Addendum #3
Avon-Washington Township Public Library
Addition and Furniture Project

Date: August 6, 2025
Project: Avon-Washington Township Public Library – Addition and Furniture Project
Project #: 24029
Pages: 24
Bid Dates: THURSDAY, August 14, 2025 at 2:00 pm (prevailing local time)

Sheet E2-1 Main Level Lighting Plan

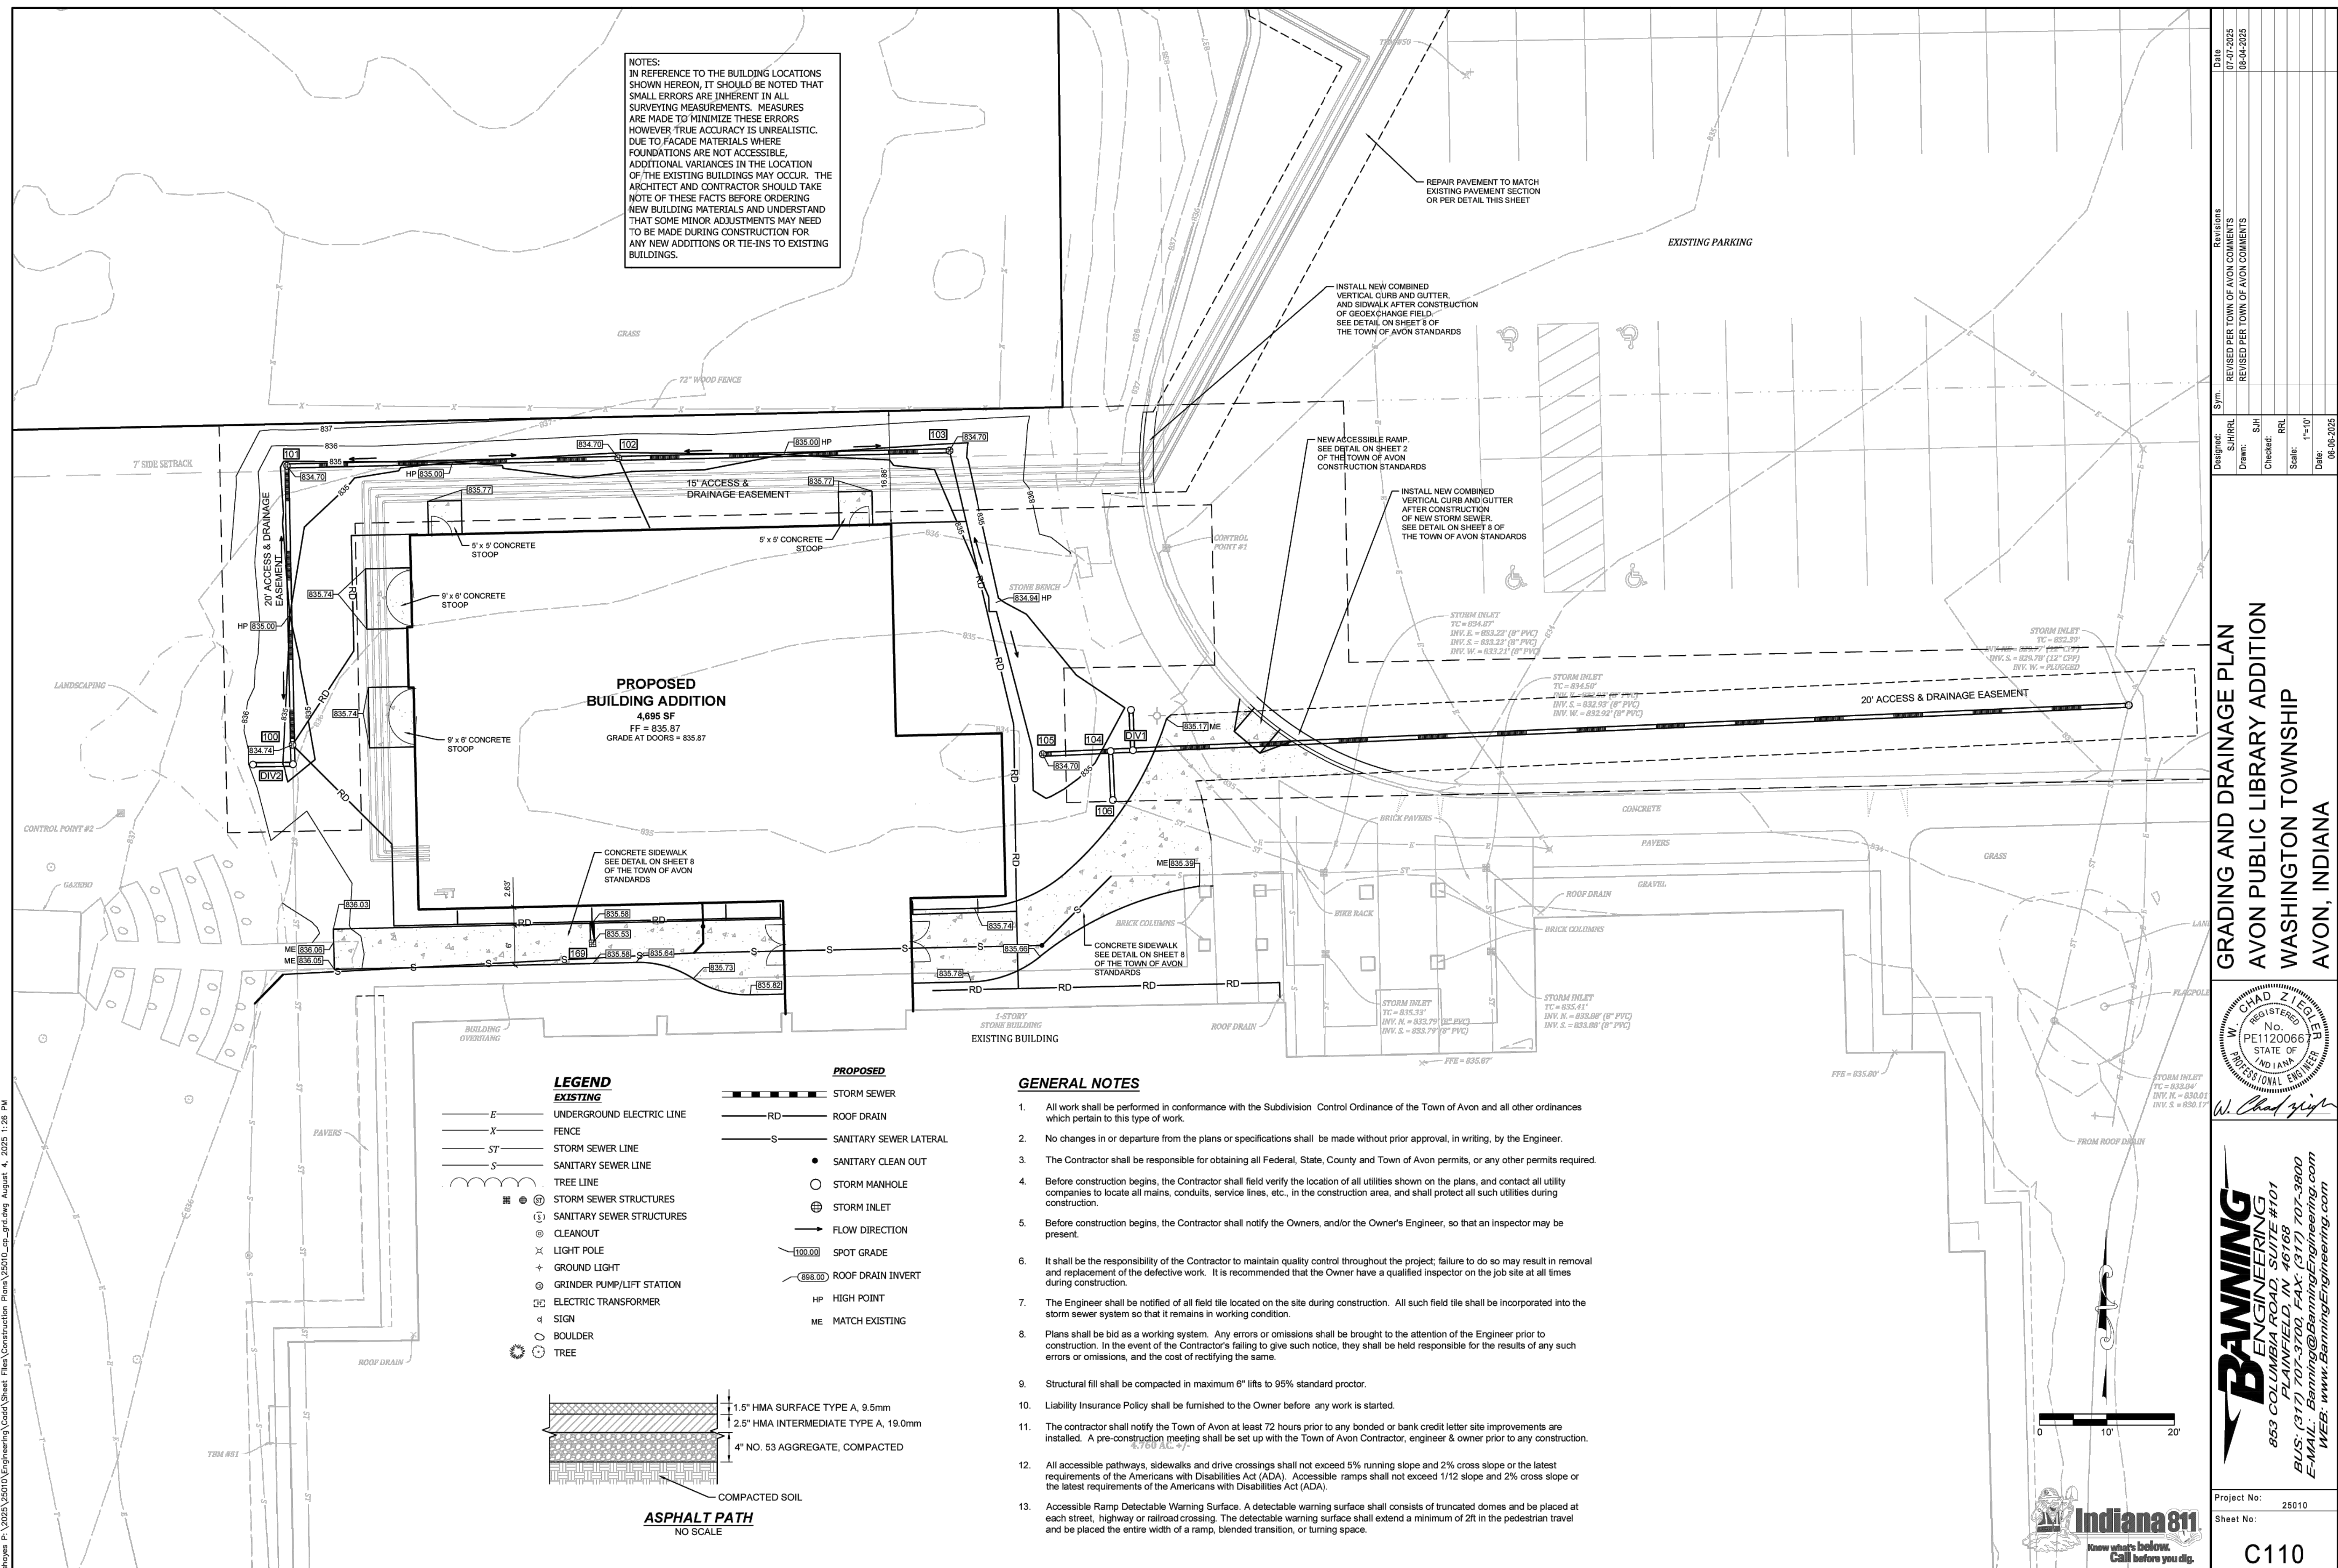
1. REISSUE sheet in its entirety.
2. Added a new fixture to Children's play area. See sheet E2-1.
3. There is one type R4 light fixture not labeled next to RR 273. ADD R4 fixture. See sheet E2-1 for revision.
4. Delete unused fixture W6 from the light fixture schedule.
5. Add to plan note 9, "Keep conduit at the bottom of the metal deck. Install hanging accessible junction boxes at the pendant & hanging location of the lights that are hung from the bottom of exposed ceiling. Electrical connection to lights and other electrical items are to be thru accessible junction boxes."

- a. See clarification above.
 20. Sheet E2-1 appears to show one recessed can light without fixture type below RR 273. Please advise.
 - a. See clarification above.

8. FIELD VERIFY LIGHT LOCATIONS THIS ROOM.
 9. RUN CONDUIT FOR CEILING-MOUNTED ELECTRICAL DEVICES ABOVE ROOF DECK STRUCTURE. NO CONDUIT SHALL BE SURFACE-MOUNTED OR VISIBLE FROM WITHIN THE FINISHED SPACE.

Sheet C110 – Grading and Drainage Plan

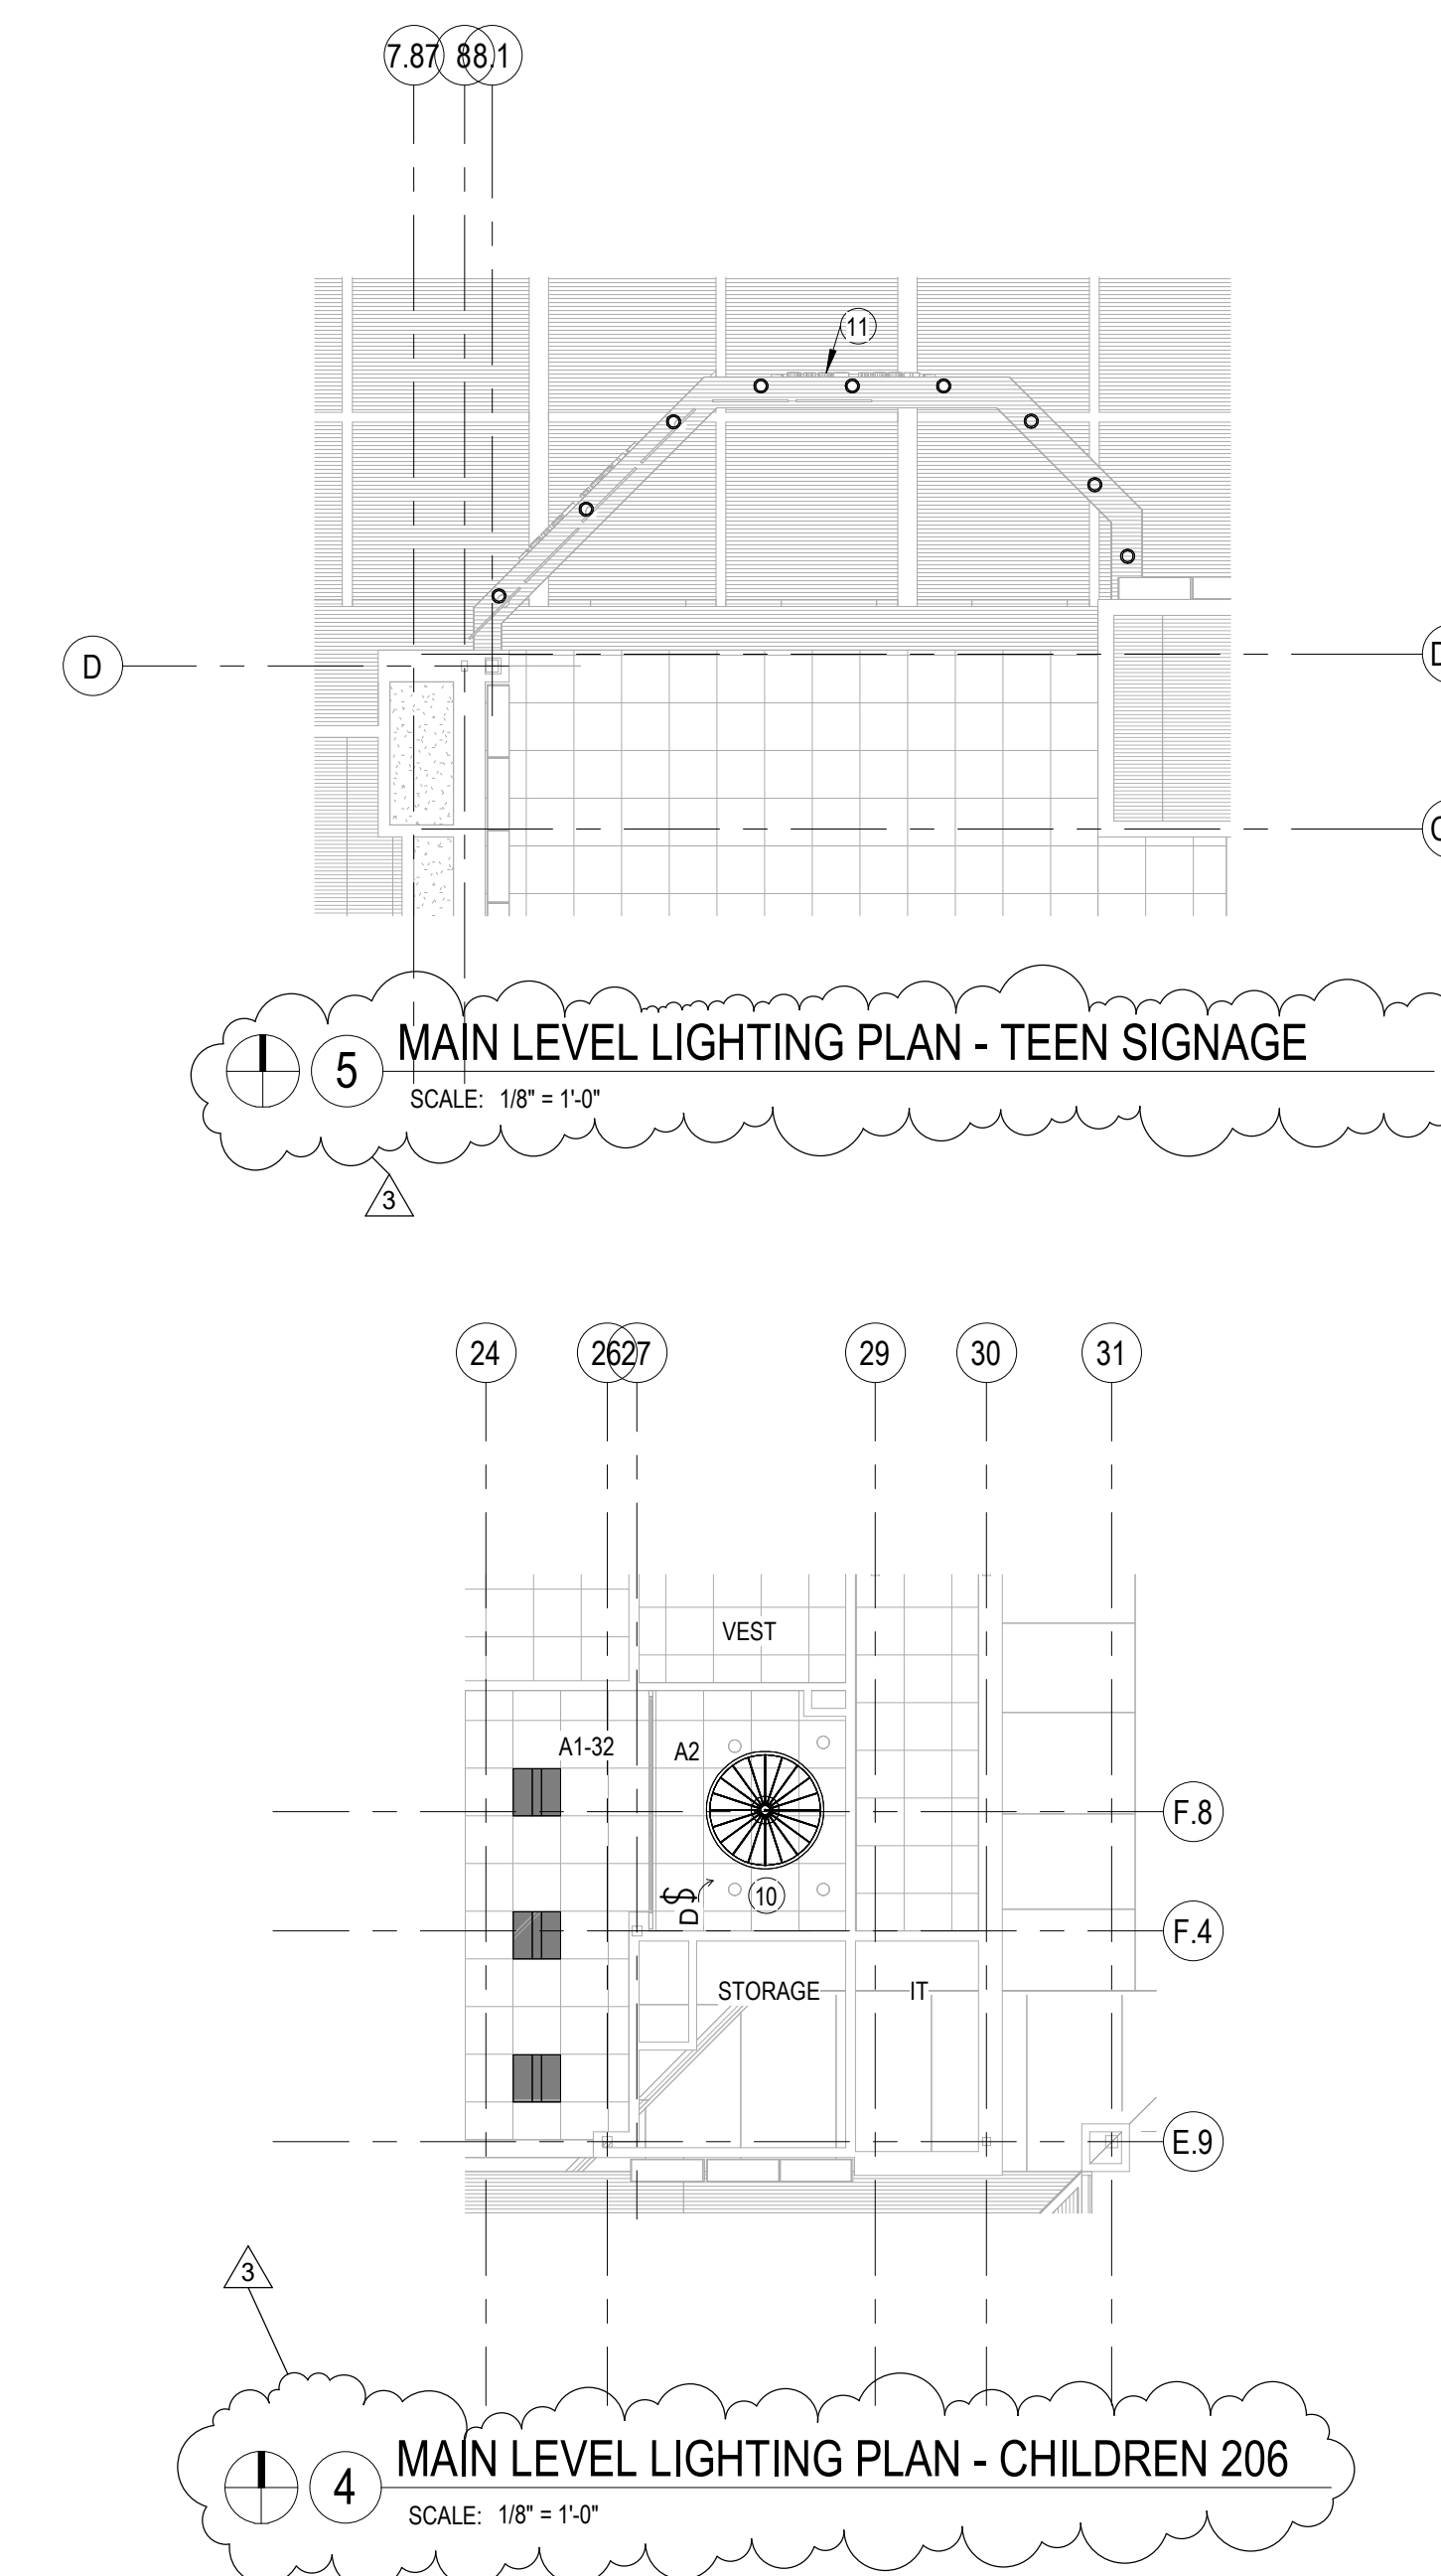
1. REISSUE sheet in its entirety to clarify the asphalt patching requirements.
